Attachment 4: Written Comments received to date

Sierra Club testimony to MoCo Planning Board On Veirs Mill Corridor Master Plan

Public Hearing Comments Veirs Mill Corridor Master Plan April 26, 2018

CONCEPT SITE PLAN

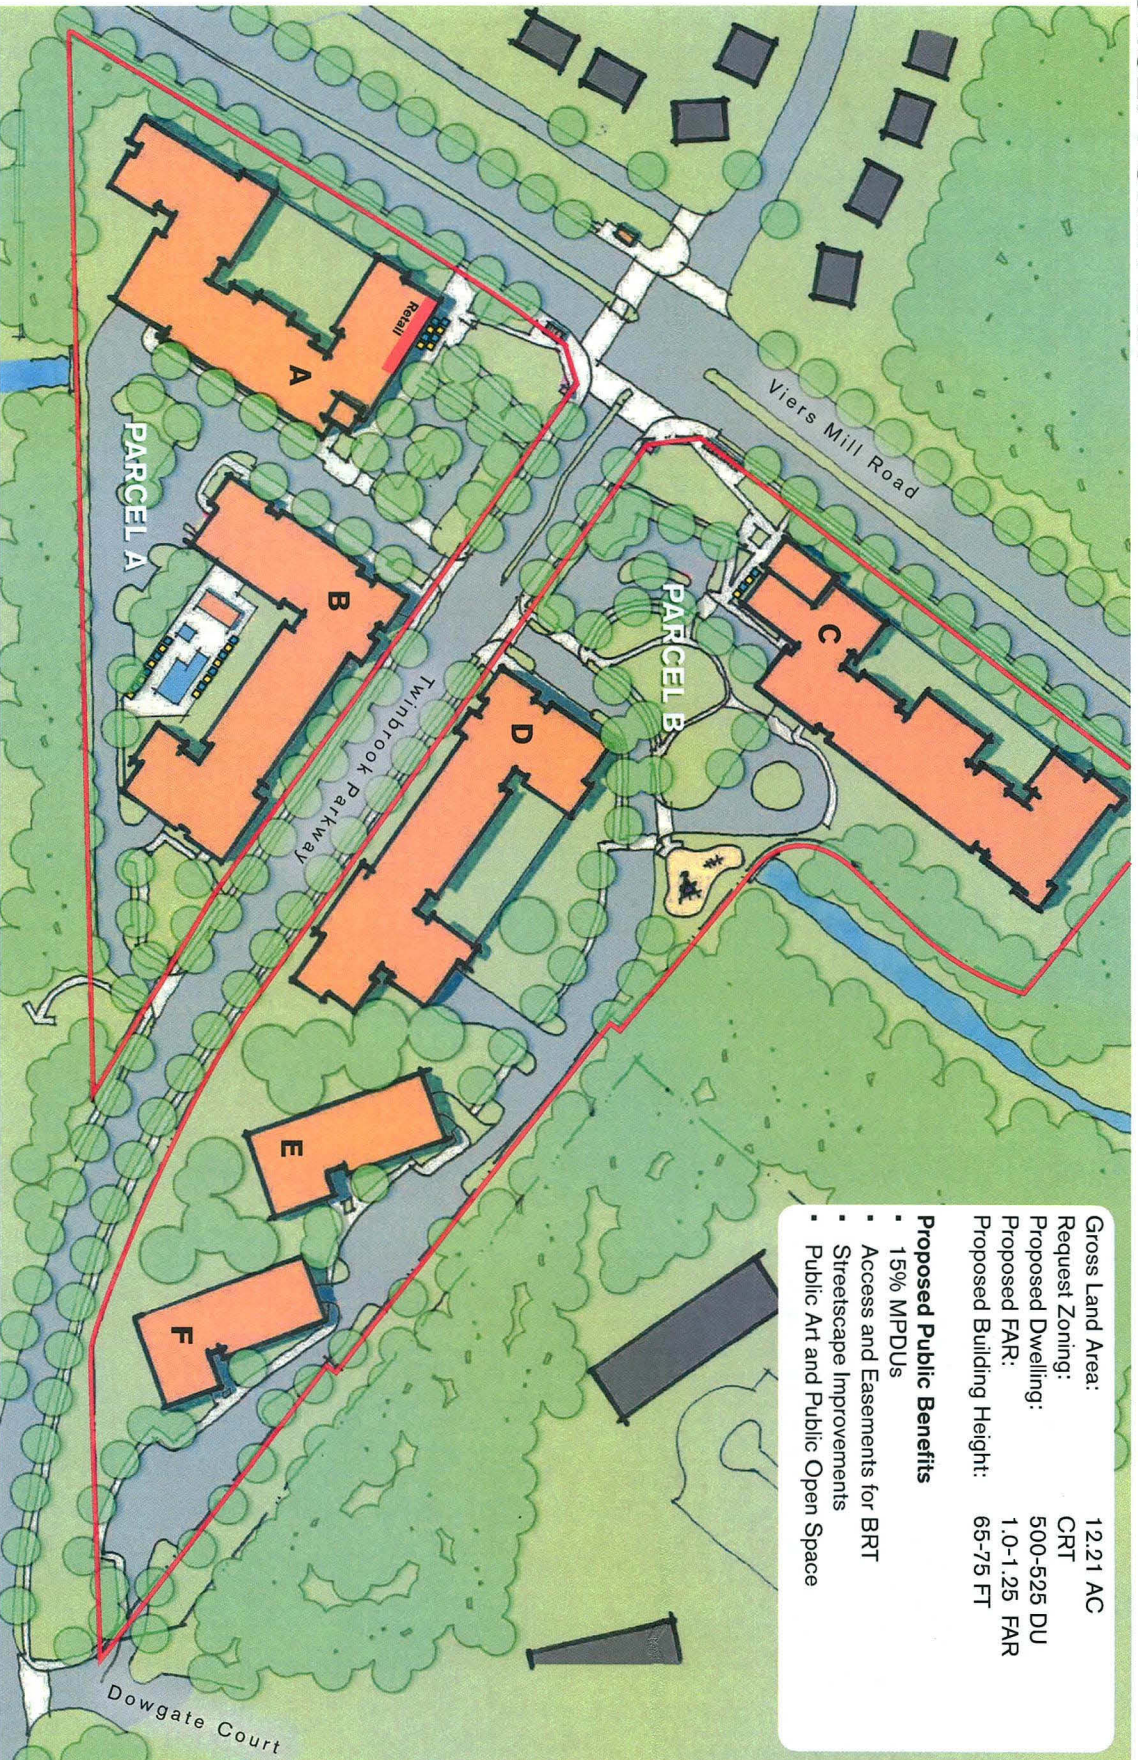
For the foregoing reasons, RCW respectfully requests that the Planning Board recommend the rezoning of this property to CRT with an FAR of 1.25 and height of 75'.

Map 20: Connecticut / Randolph Proposed Zoning

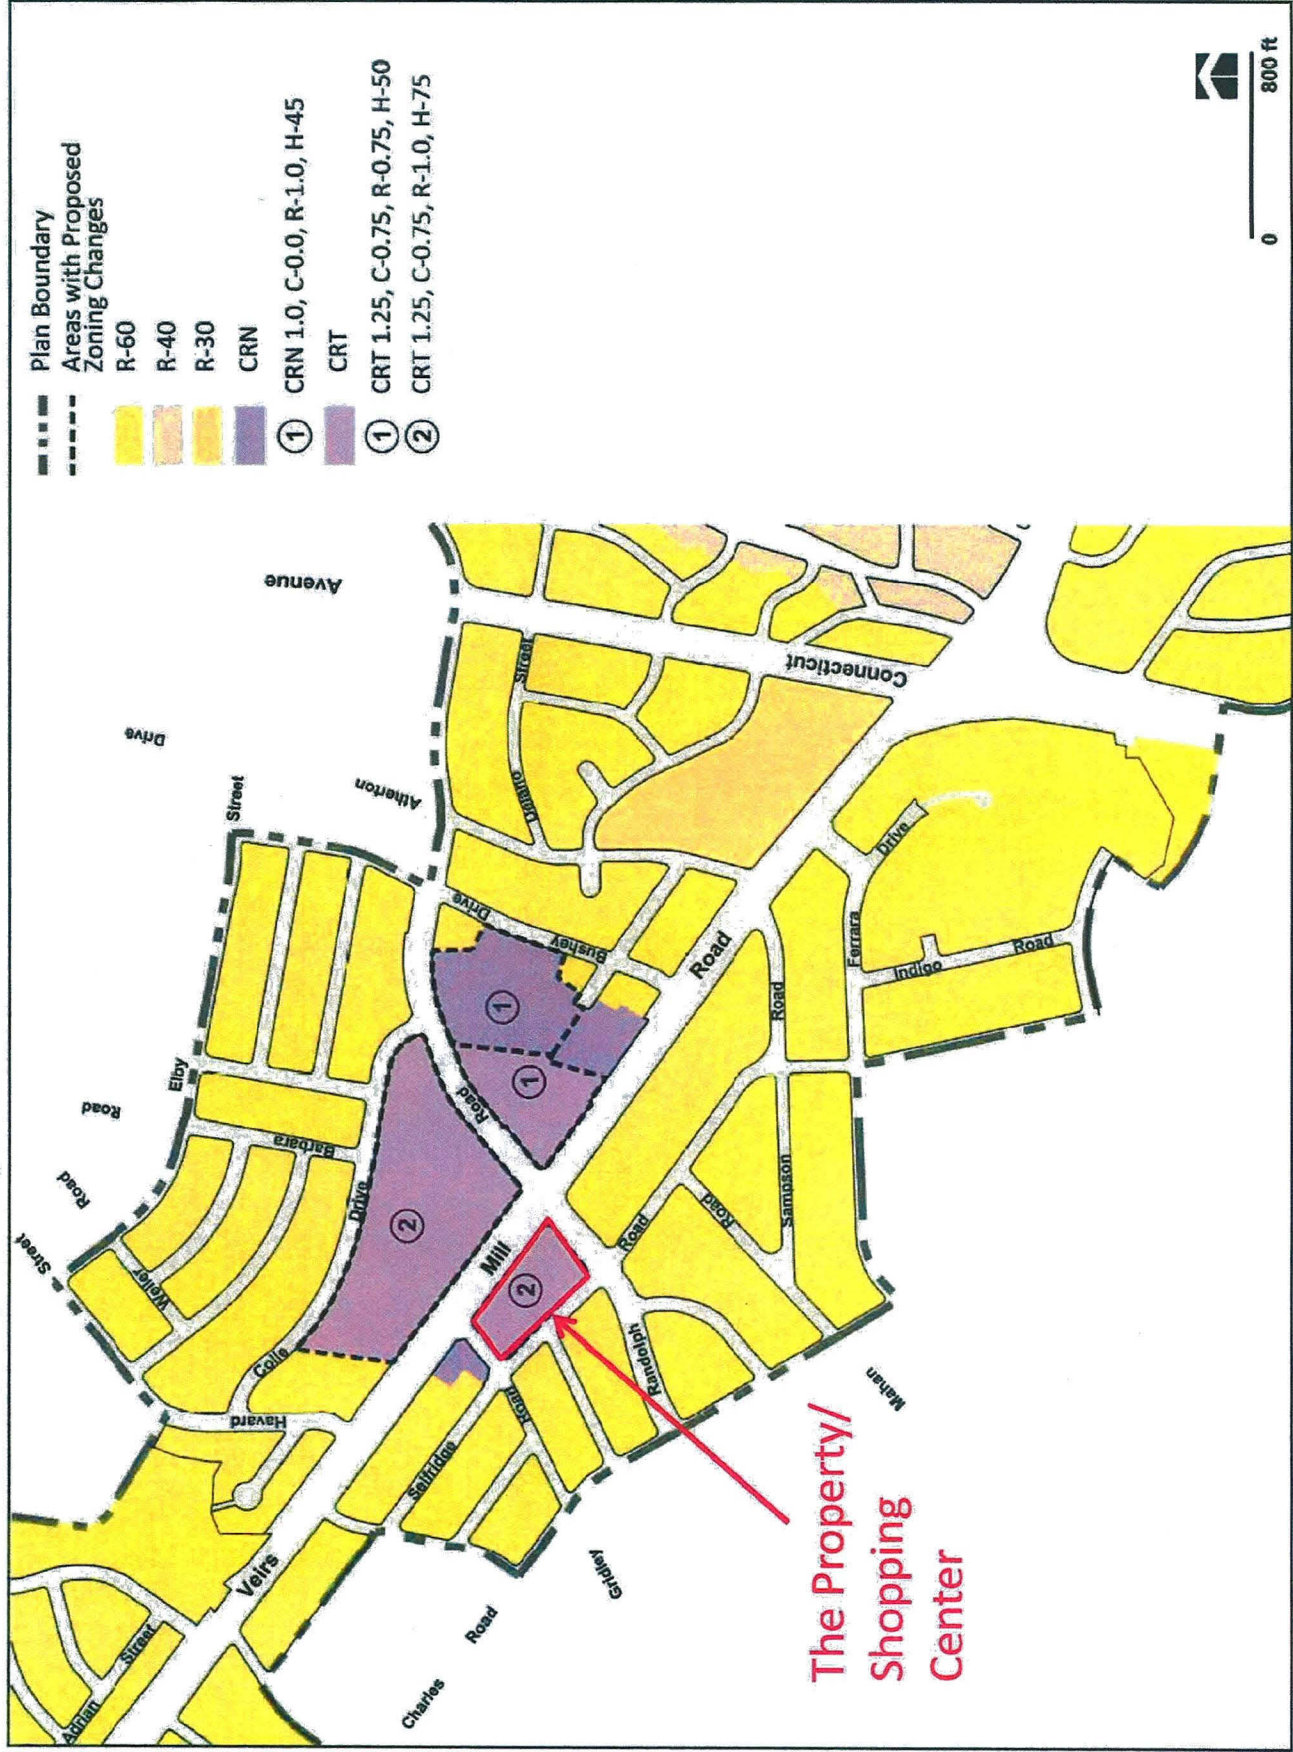
1. Equalize the density potentials of commercial and residential by rezoning the Property to CRT 1.25, C-1.25, R-1.25, H-75, to allow the maximum permitted density for the Property to be allocated more readily between either commercial and/or residential uses, based on market demands;
2. Provide sufficient flexibility to allow interim, incremental reinvestment in the Shopping Center without having to accommodate all end-state master plan expectations;
3. Ensure that the proposed transportation infrastructure improvements can be accommodated within the existing right-of-way so as not to physically interfere with the Shopping Center; and

The Public Hearing Draft currently recommends the creation of a public open space of ¼ acre on the Property. VMR recognizes the benefit of open space on the Property in connection with any comprehensive redevelopment. However, the exact location and configuration of the open space should be determined at the time of redevelopment. The Master Plan should not be unnecessarily prescriptive in requiring either a certain land area or that all the public open space be provided in one central location. The siting, configuration, and size should be determined in the review of a specific development proposal, not a theoretical exercise. Several smaller, more intimate open space areas may ultimately be more successful, depending on the future redevelopment concept.

Figure 1, Vision Zero Concept with grade separation at Veirs Mill and Randolph, looking South from the North Corner (base map areal view credit: google maps).

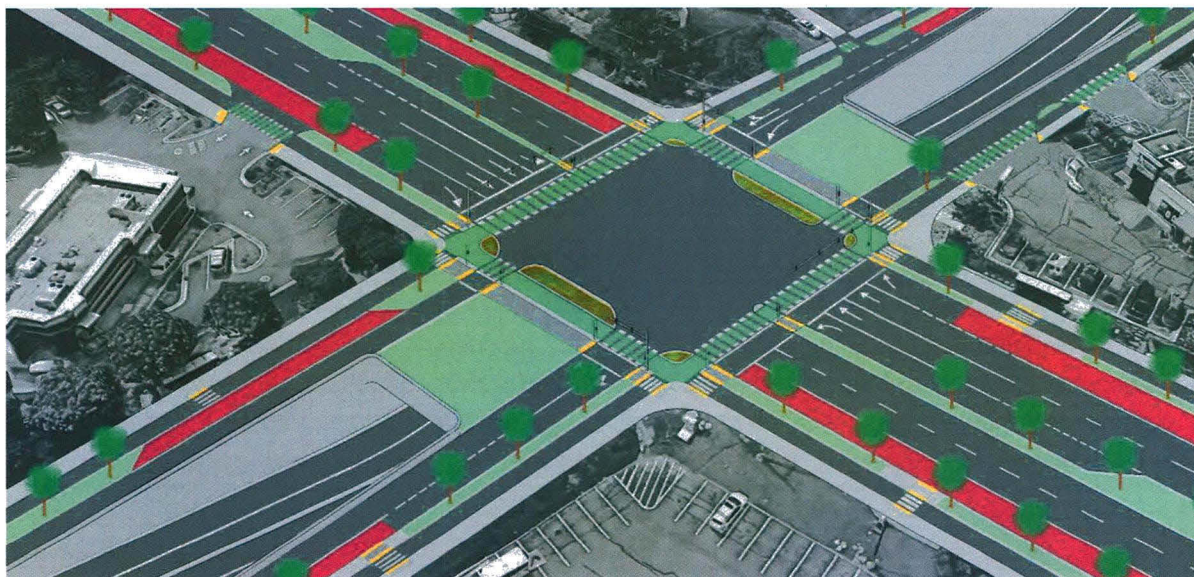
This is an alternate proposal to the Veirs Mill Corridor Plan's recommendation to eliminate the proposed grade separation at Veirs Mill Rd. and Randolph Road from the 2004 Master Plan of Highways and Transitways. The plan (v. 3-16-18) on page 52 states "A grade-separated interchange at this intersection is inconsistent with the overall transportation goals of this plan, which seek to improve conditions for pedestrians, bicyclists and transit users on Veirs Mill Road and the surrounding communities". We wish to challenge this premise and demonstrate a grade separation design that is consistent with the plan's objectives and provides a superior solution than the status quo for all stakeholders.

Figure 17 from the corridor plan illustrates features of road treatments and alignments conceptually. However, it fails to illustrate how these features would be applied at the scale of the real intersection at Veirs Mill and Randolph. Therefore, we submit the following:

This conceptual design incorporates the intersection treatments consistent with a protected intersection design. It provides for: countdown signals, high visibility crosswalks, pedestrian refuge islands, physical barriers separating bicycle lanes, curbed extensions protecting bicycle and pedestrian crossings, and dedicated lanes for transit. It is consistent with the lane alignments for Veirs Mill Road illustrated on Figure 11 from the corridor plan. Also, due to the grade separation, which eliminates Randolph thru traffic from light timing considerations, the number of left turn lanes from Veirs Mill road can likely be reduced to one lane for each turn as recommended in section 2.5.3: Street Network Recommendations. With incorporation of pedestrian refuge islands, the maximum number of lanes for a pedestrian to cross is reduced to a maximum of four.

We respectfully request that this design be included in the plan in some fashion, if at the very least as an alternative intersection recommendation.
